Behri Kala Ro Raktak

OPTION - IV

DATE	06-11-2018
TITLE	REMOVED VPO SINGH SIKHAN BRANCH, CHANDER DHADE KALYAN
DESIGNER ASSOCIATES	ARCHITECT INTERIOR DESIGNER
PROJECT NO.	PA1429CK/SHK
DEL-1-11025	0811061148
EMAIL	interior@protonmail.com

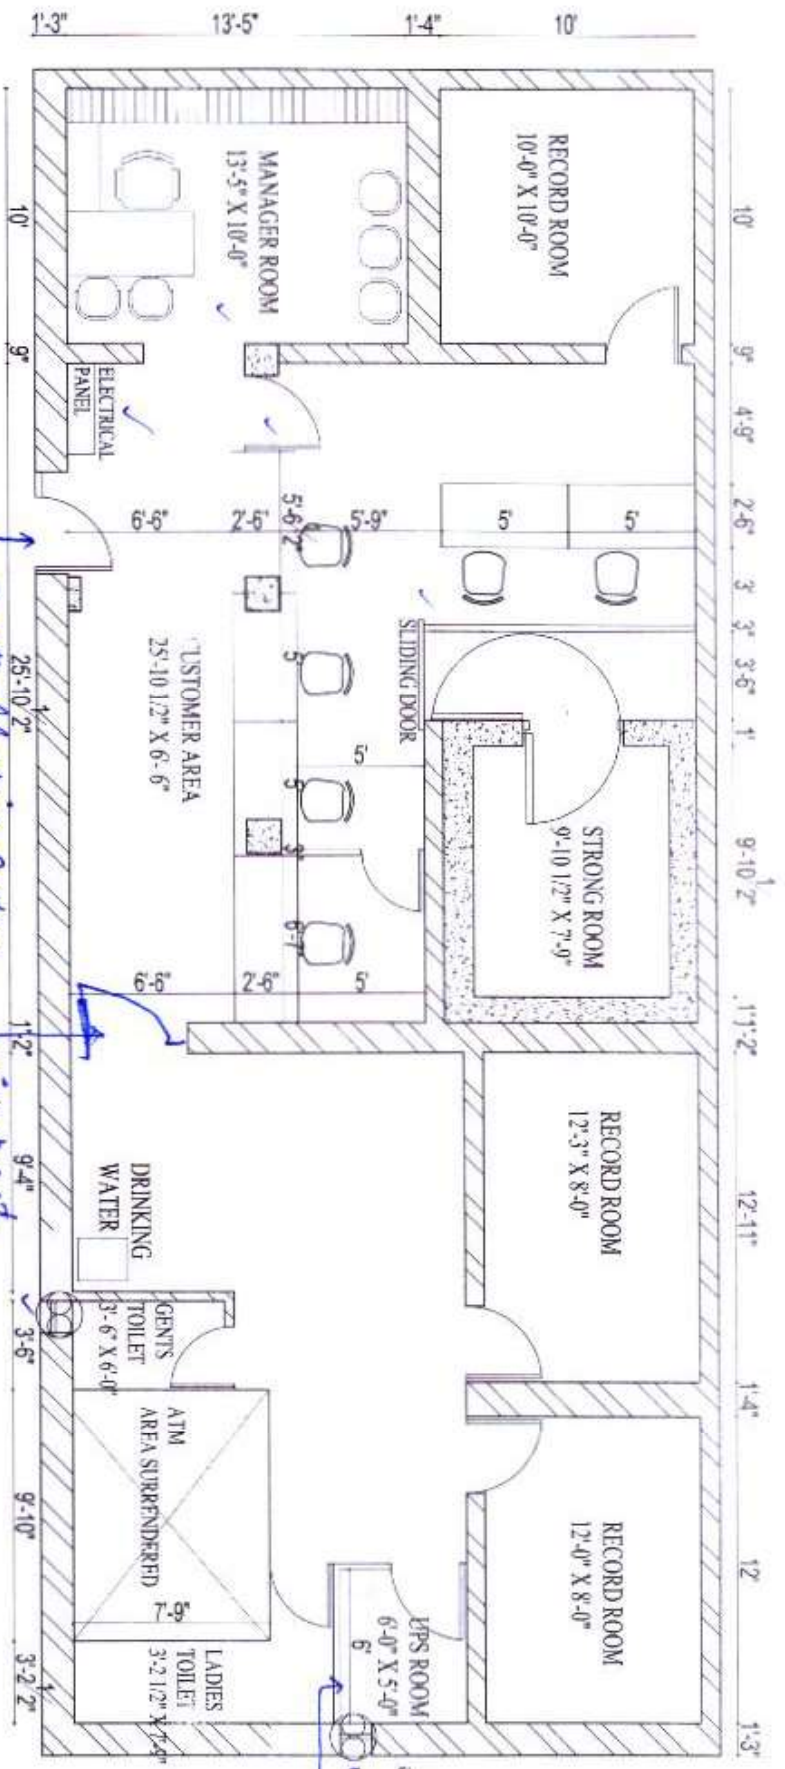
Existing premises of Behri Kala branch having number of windows and all should be closed permanently with brick wall as incidents of burglary happened in the branch. Security clearance to be lay out & provided subject to compliance & observations.

Central locking system to be provided.

wicket gate to be provided to restrict movement in record room area.
